**CITY OF NOVI CITY COUNCIL**  
**MARCH 23, 2026**

**SUBJECT:** Consideration of final approval for Zoning Map Amendment pertaining to The Grove, a 232-unit multiple-family townhome development.

**RECOMMENDED ACTION:** Approval of the request of Ivanhoe Companies for The Grove JZ24-31 with Zoning Map Amendment 18.745, to rezone from Office Service Technology (OST) to Low Density Multiple Family (RM-1), subject to the attached Planned Rezoning Overlay (PRO) Agreement and exhibits including the corresponding PRO Plan, the conditions of this motion, and the conditions listed in the staff and consultant review letters, and also subject to any changes and/or conditions as discussed at the City Council meeting, with any final minor alterations required in the determination of the City Manager and City Attorney to be incorporated by the City Attorney's office prior to the execution of the final agreement.

**PUBLIC BENEFITS PLAN**  
**THE GROVE**  
NOVI, MICHIGAN

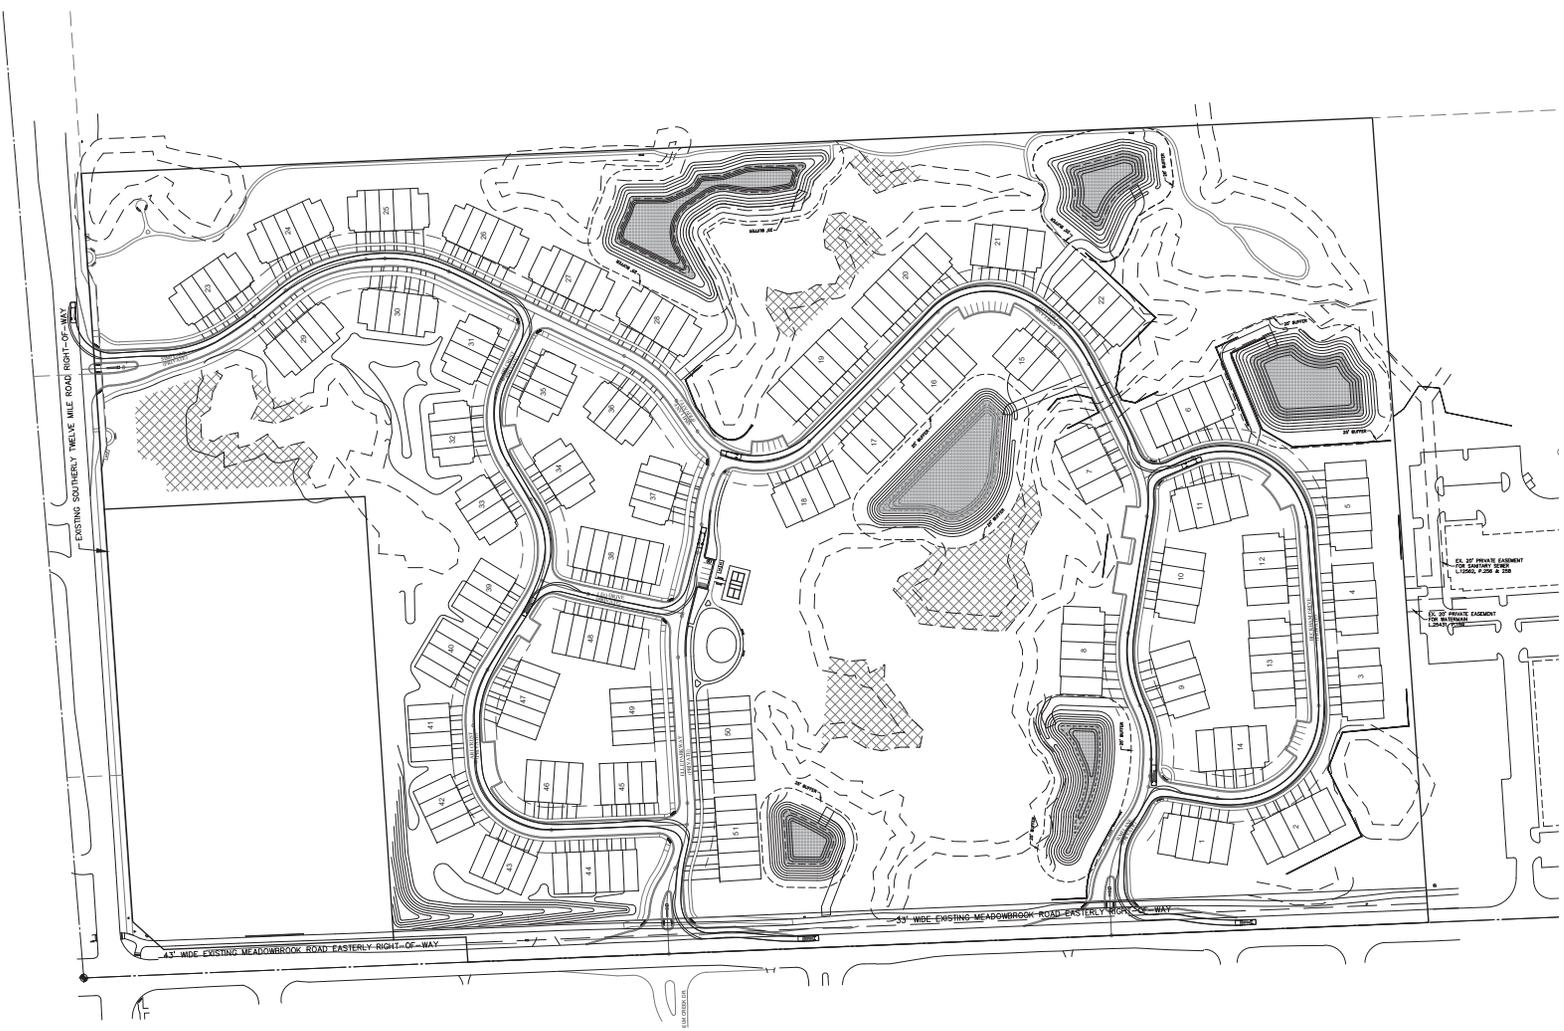
4. Consistent with Novi's mobility plans, over 700 feet of 10-foot wide pathway/sidewalk, off-site on the south side of 12 Mile Road to create a connection from the existing bike path, located along the east side of Meadowbrook Road, and the new sidewalk being constructed with The Grove. *The provision of this missing sidewalk segment enhances connectivity of the project area and benefits the public.*

5. Relocating the SMART bus stop to the east and enhancing the area with landscaping and seating along 12 Mile Road, which is supported by SMART. Additional bike parking has also been added for a total of 8 spaces. Maintenance and public access agreements would likely be required. *This would be considered a benefit to the public.*

DATE: 1/14/24 SCALE: HOR: 1" = 100'  
 VER: 1" = N/A  
 DRAWING BY: SRB JOB NO: 22149  
 DRAWN BY: DAB SHEET: SP-8.1

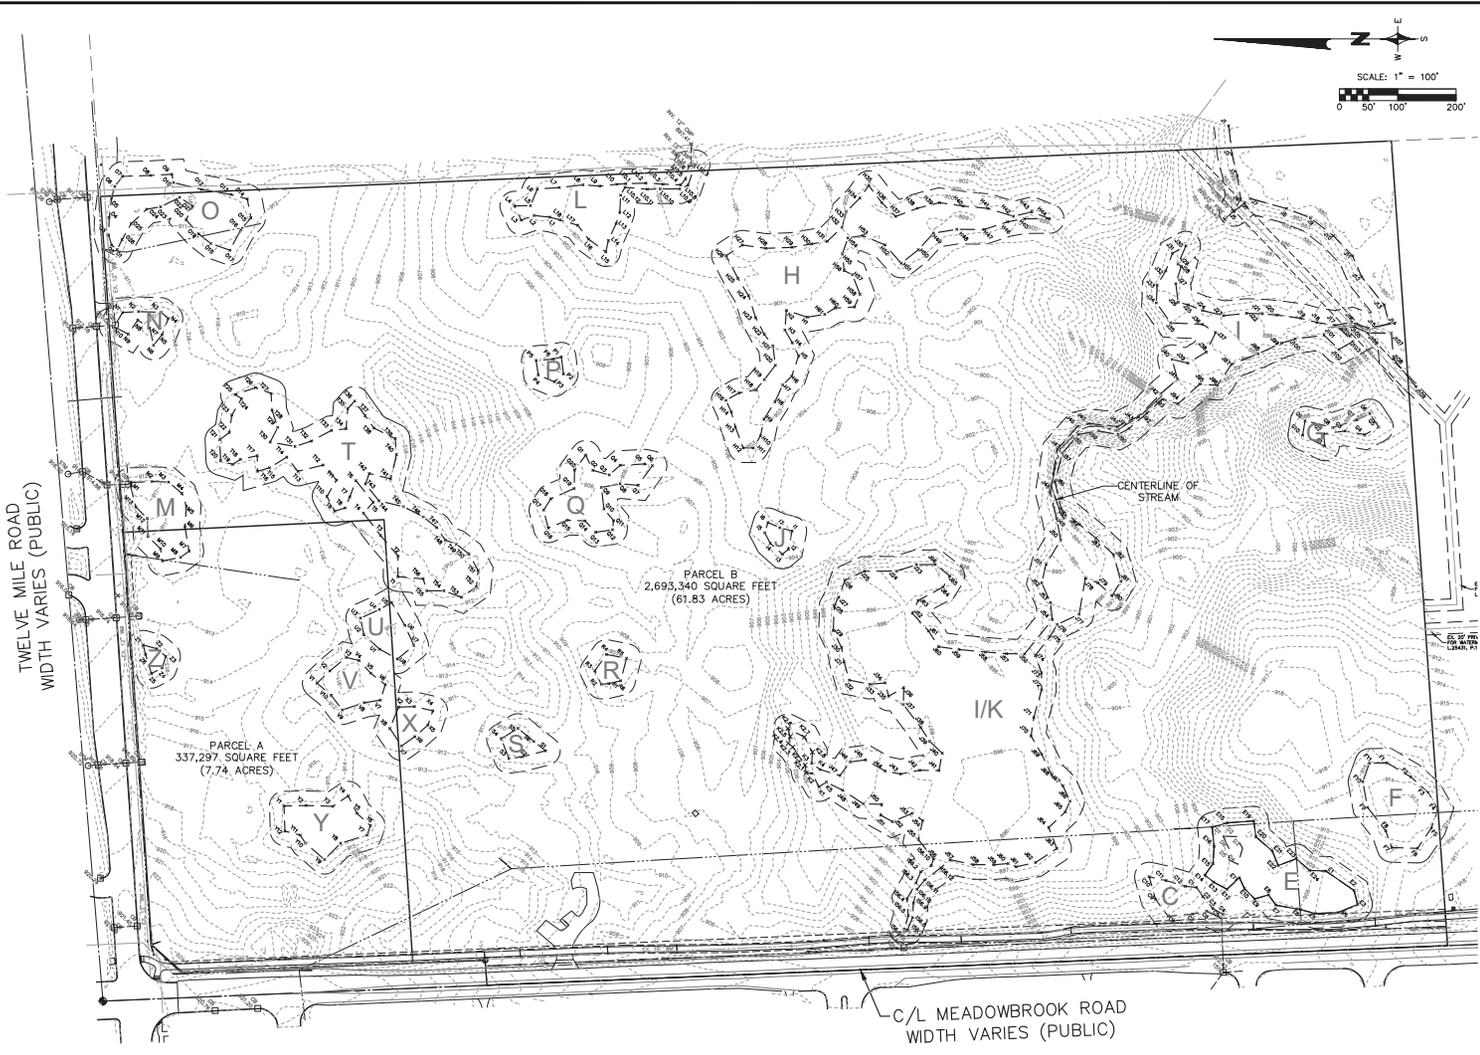
\*Classification per Sheet SP-8.1

Current wetland classifications in **Table 1** above reflect the classifications noted on Sheet SP-8.1. The total proposed impact to City-regulated wetlands is approximately 1.44 acres.
